Revised connector order on ROC

ROC Board Faces Downstream

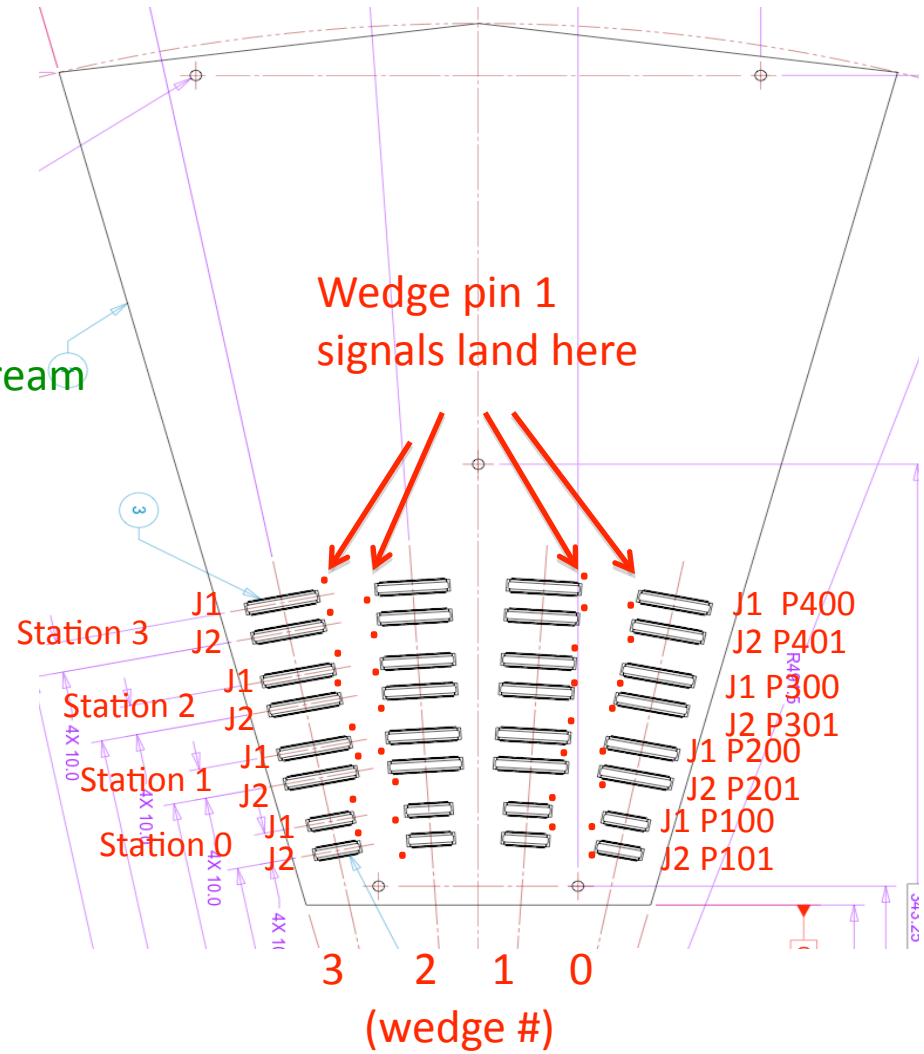
Connector pair order is always J1 above J2!

Wedge 0 faces downstream as does ROC

Wedge 0 Final Layout

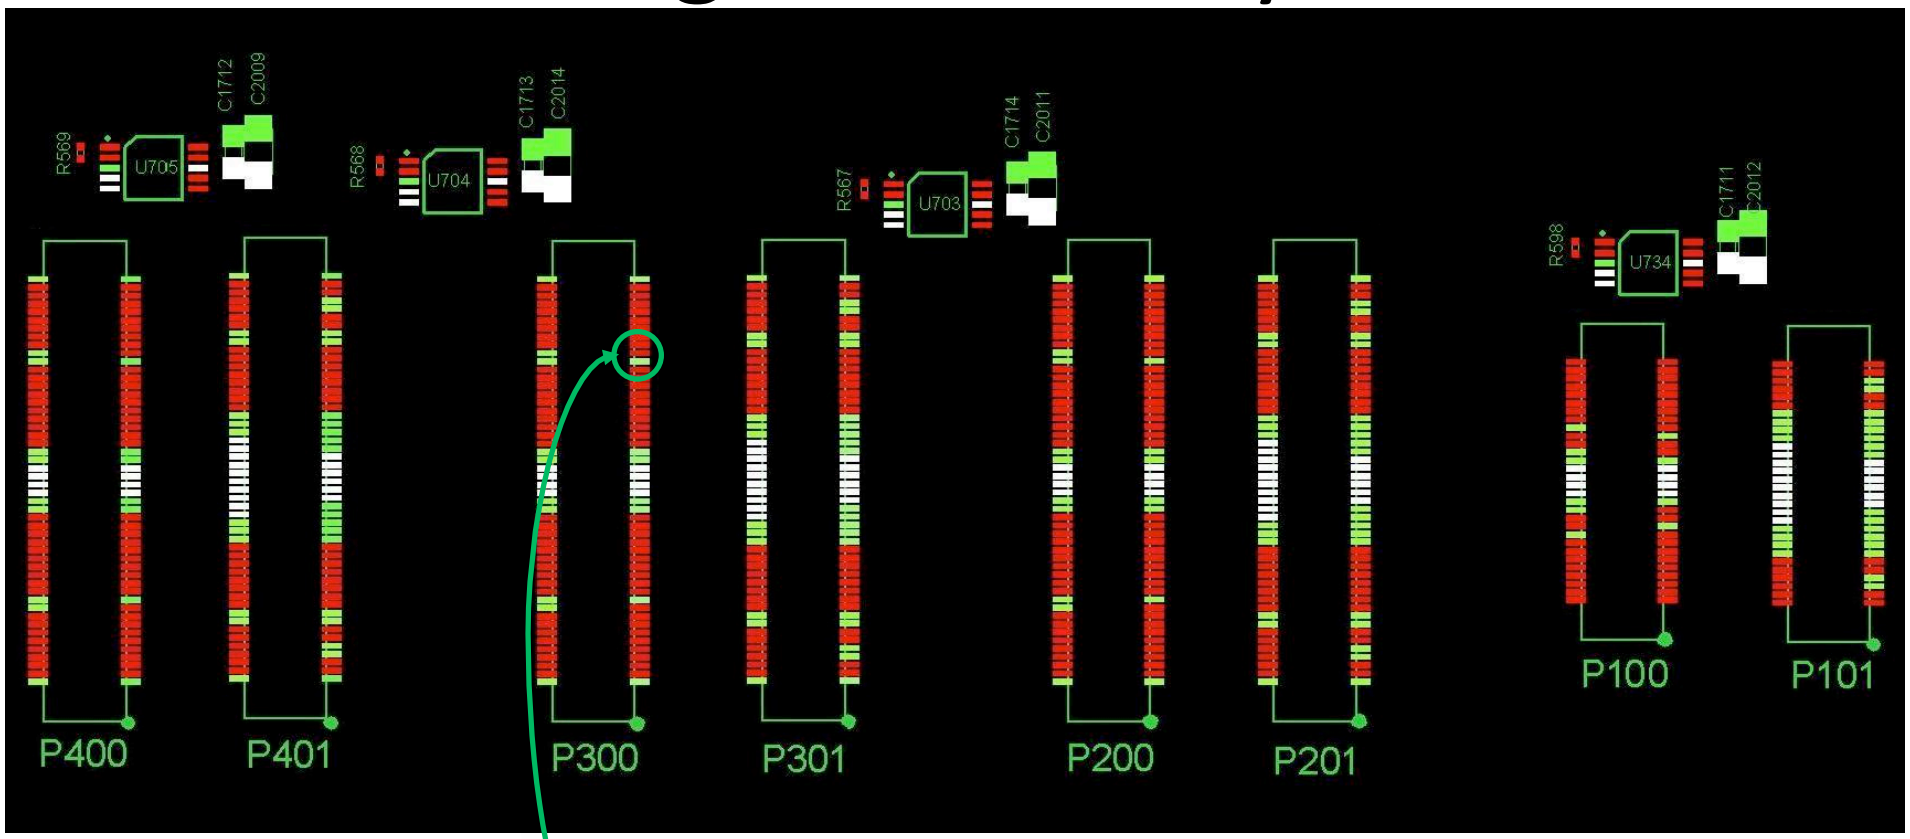
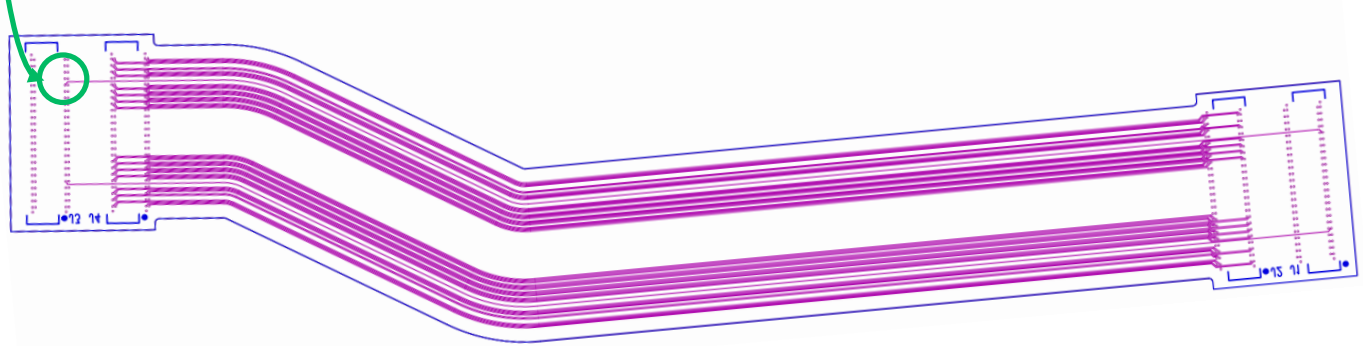
- Mating position for cable 3302
- Calibration line goes to the inside radius

Wedge 1 Final Layout

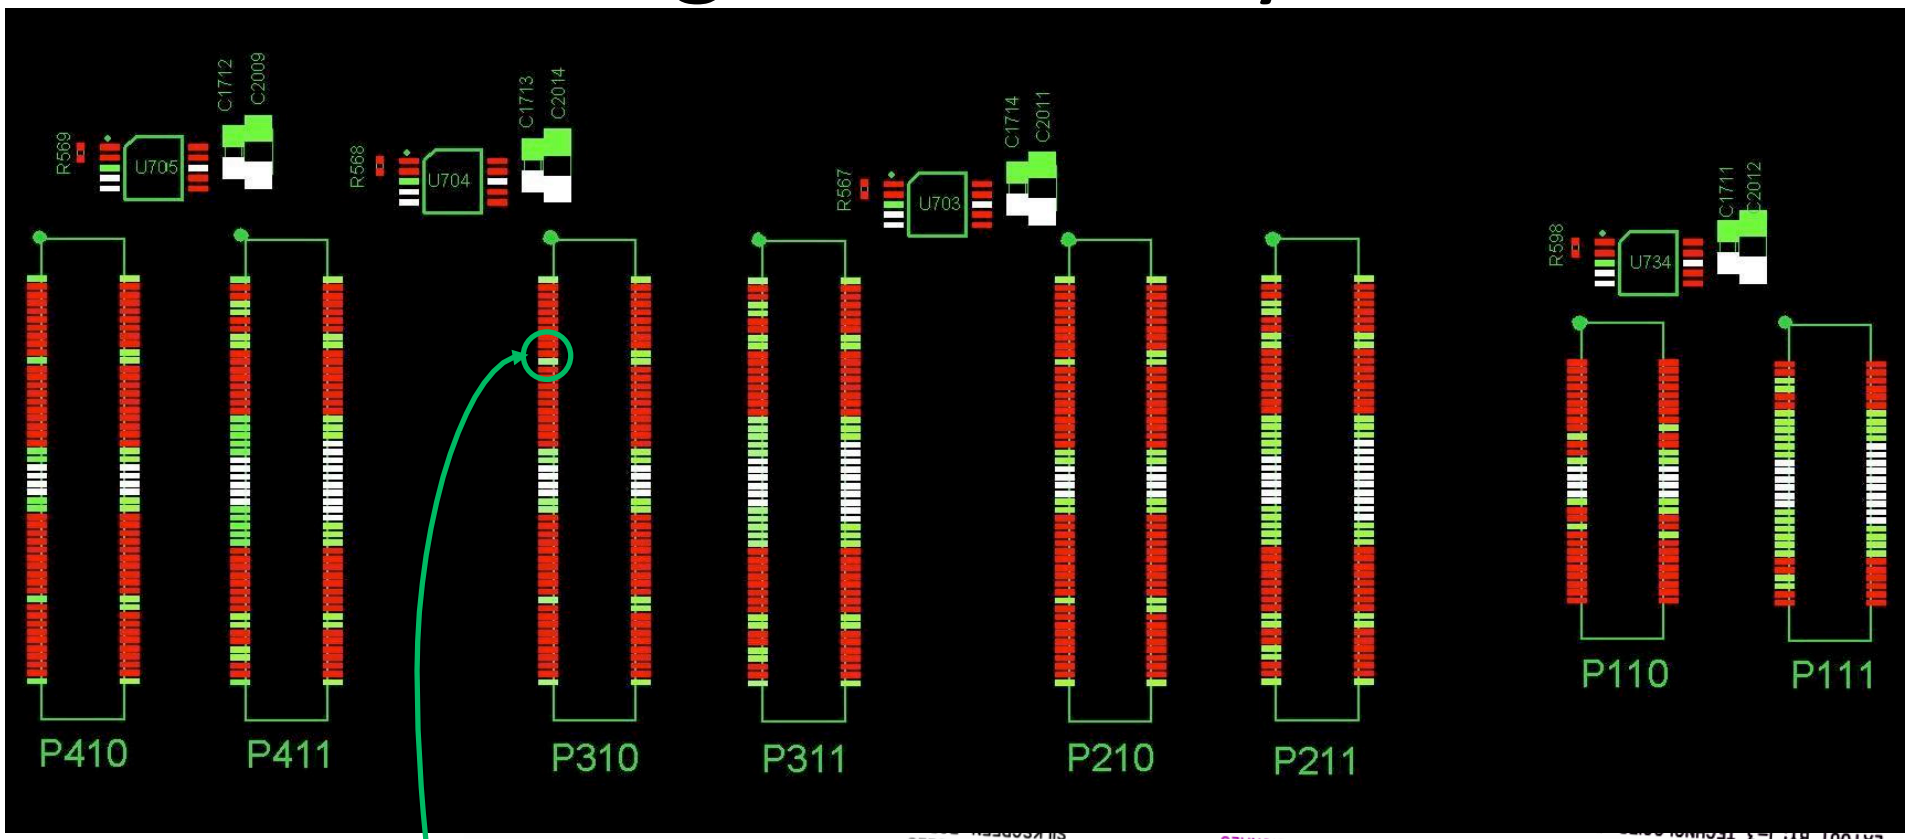
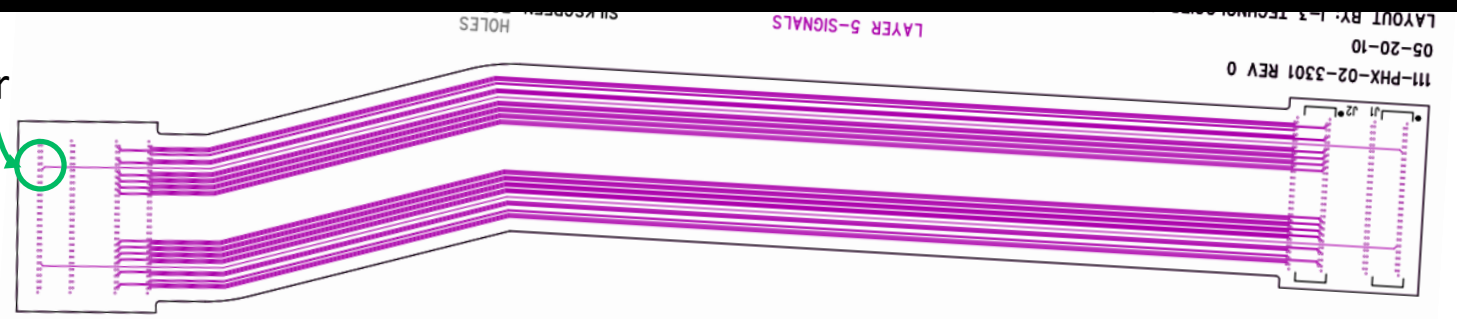
- Mating position for cable 3301
- Calibration line goes to the outside radius
